Exhibit B

License Amendment Request Dated March 1, 1988

Docket No. 50-263
License No. DPR-22

Exhibit B consists of marked up pages for the Monticello Nuclear
Generating Plant Technical Specifications showing the proposed changes as
listed below:

Figure 3.4-1 Sodium Pentaborate Solution Volume Concentration Requirements

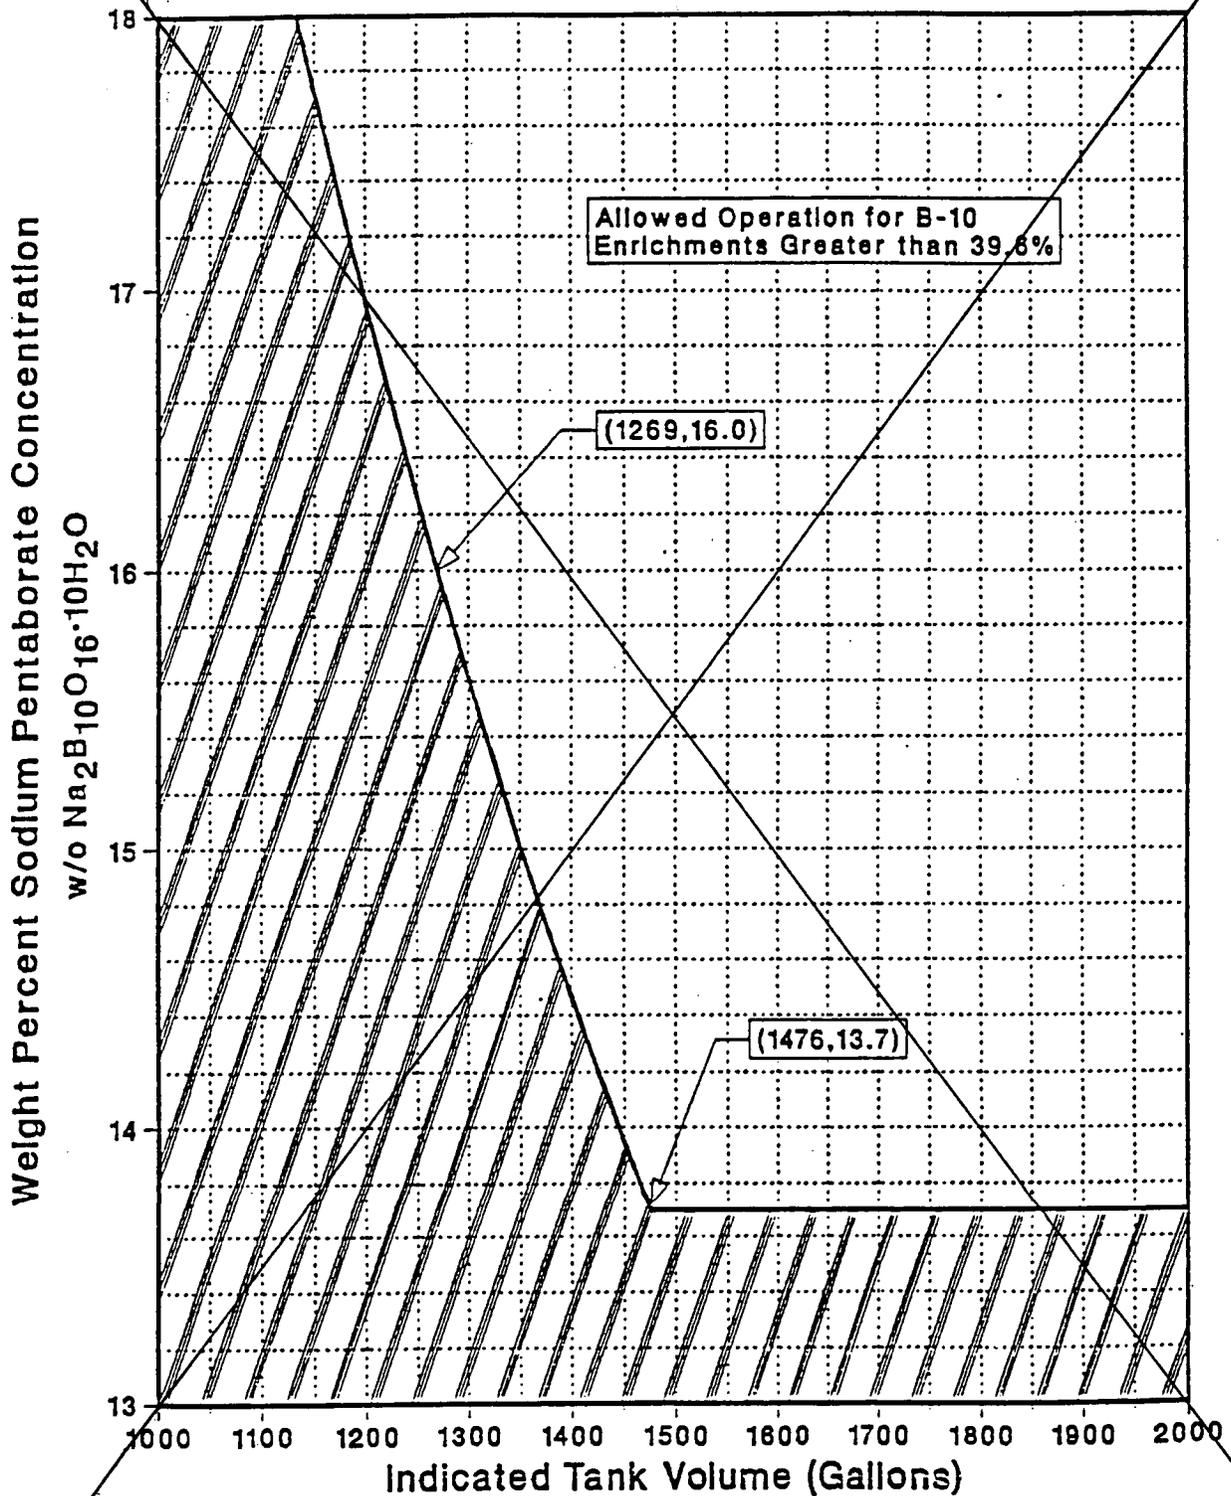
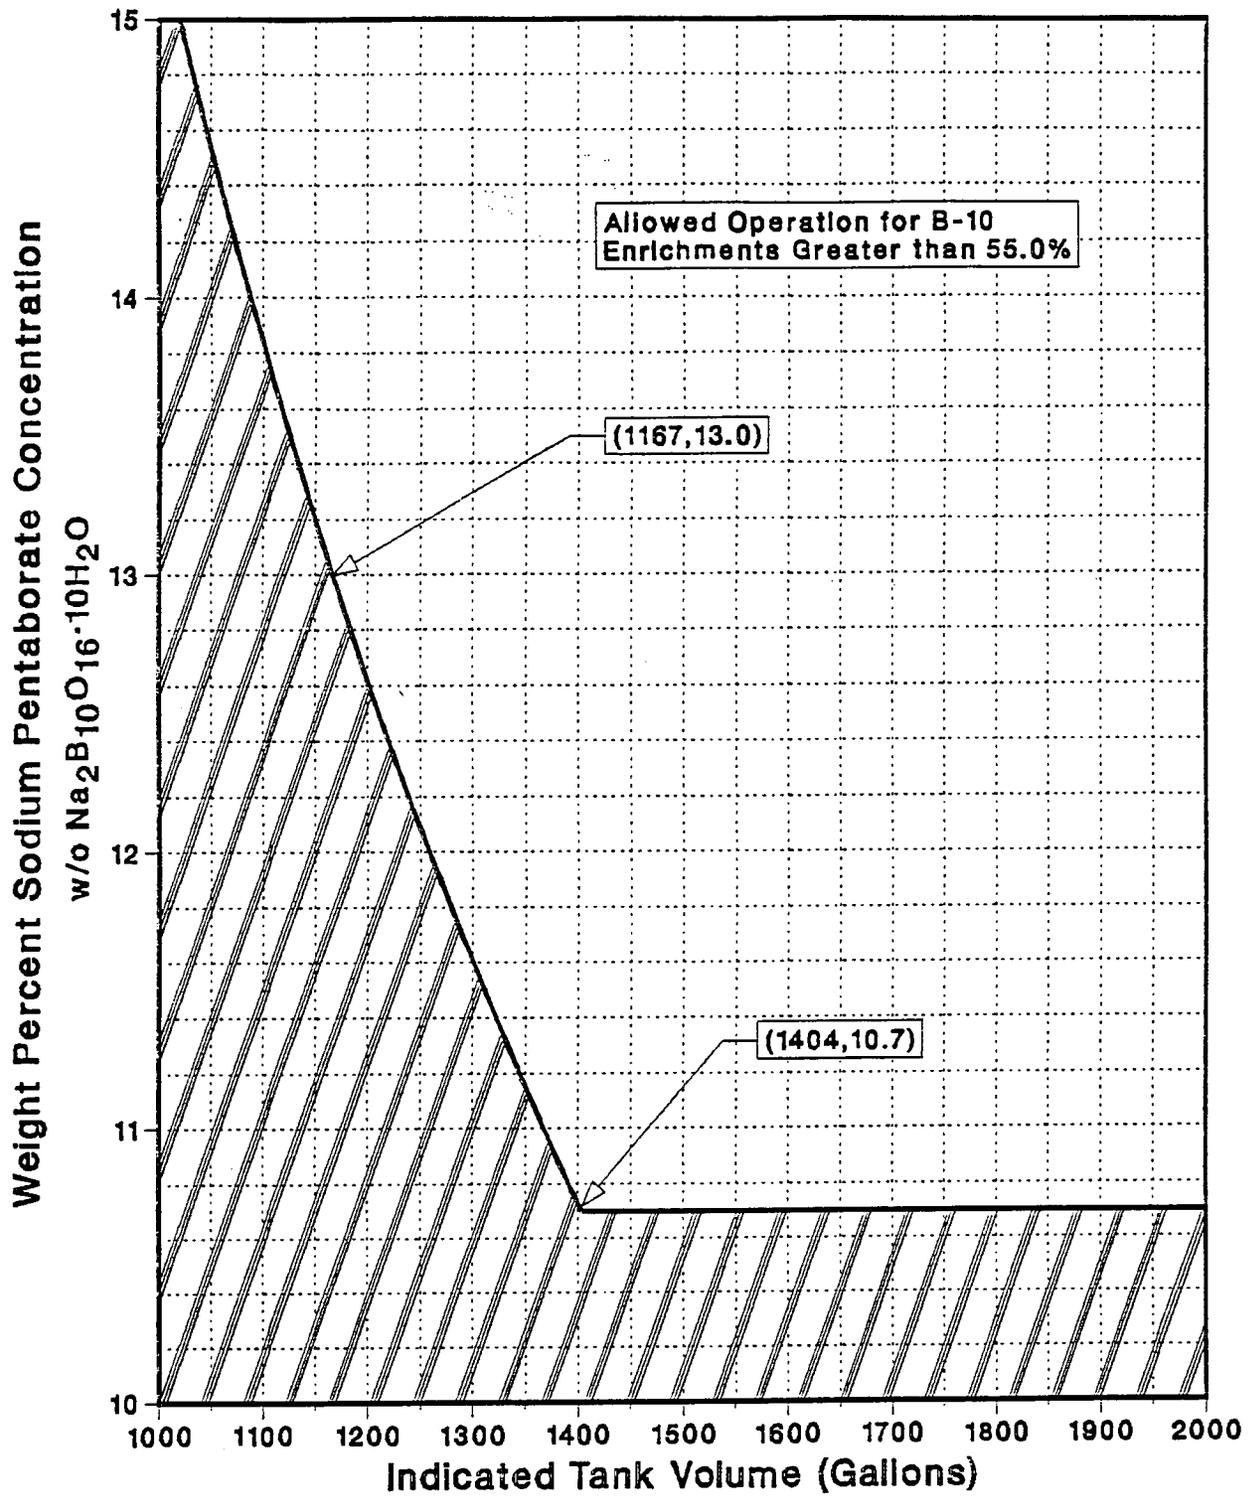
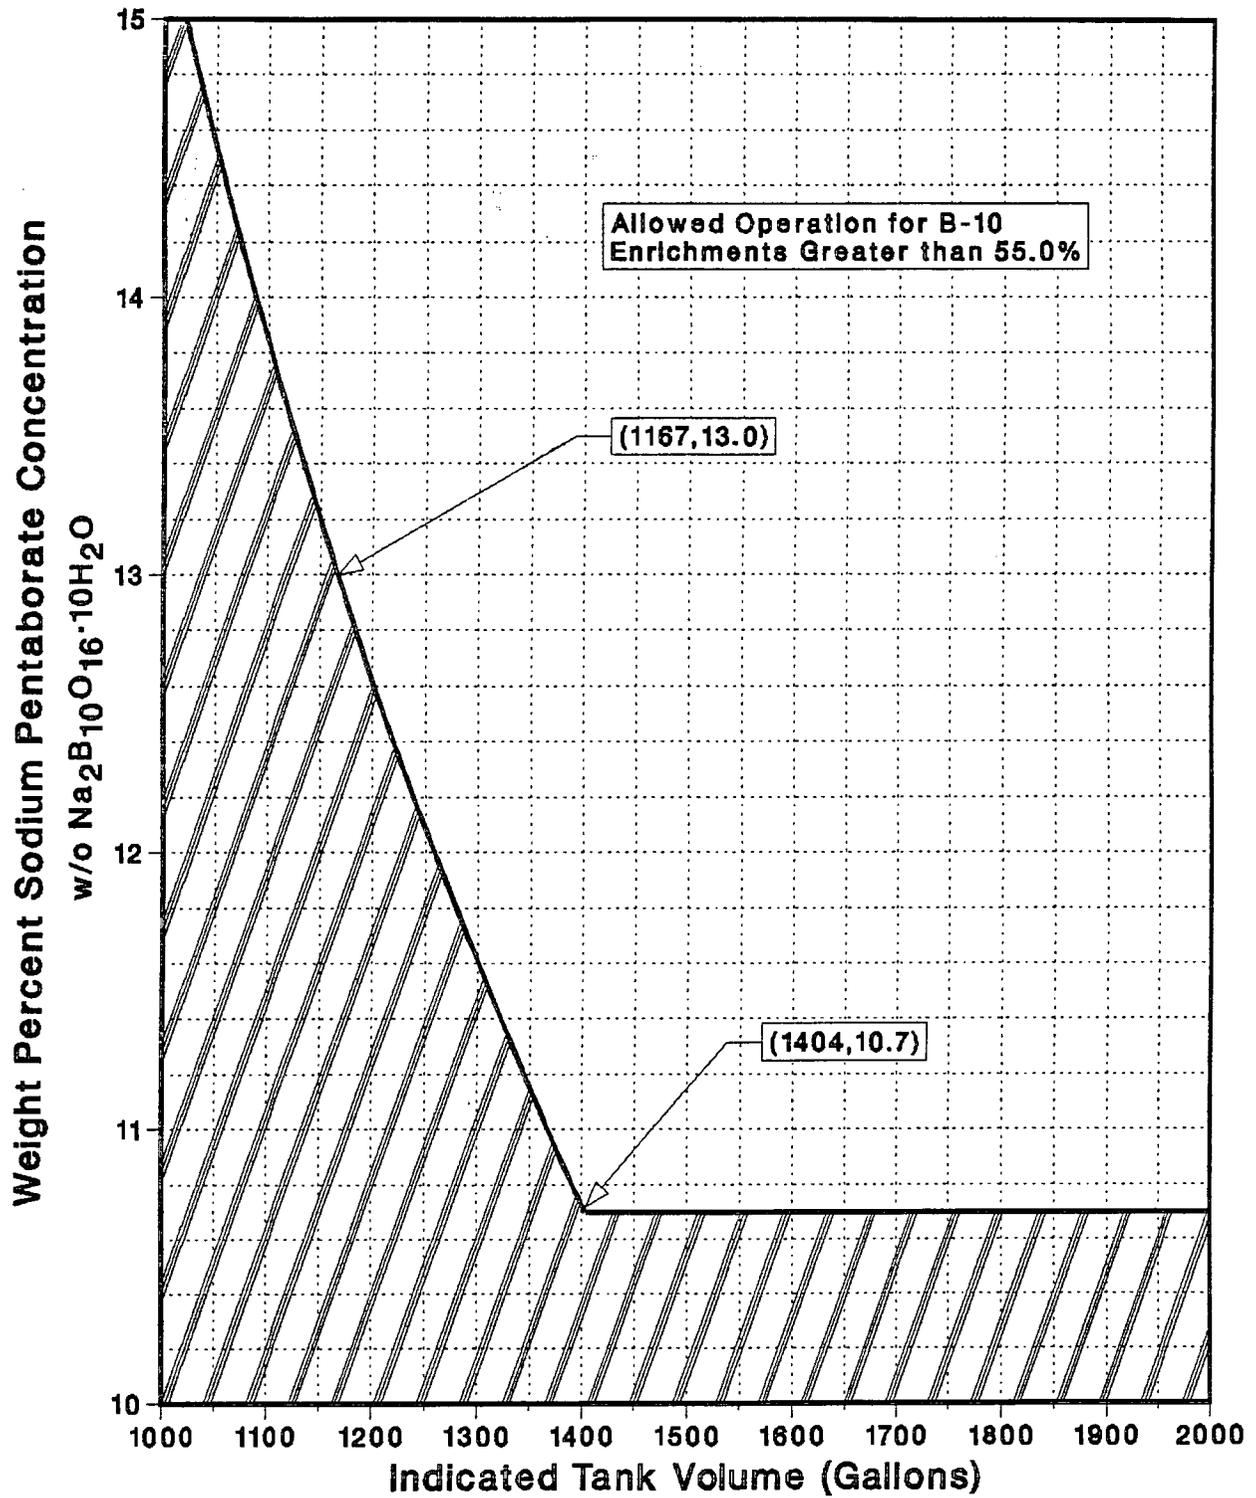
INSERT NEW

FIG. 3.4-1

Figure 3.4-1 Sodium Pentaborate Solution Volume Concentration Requirements
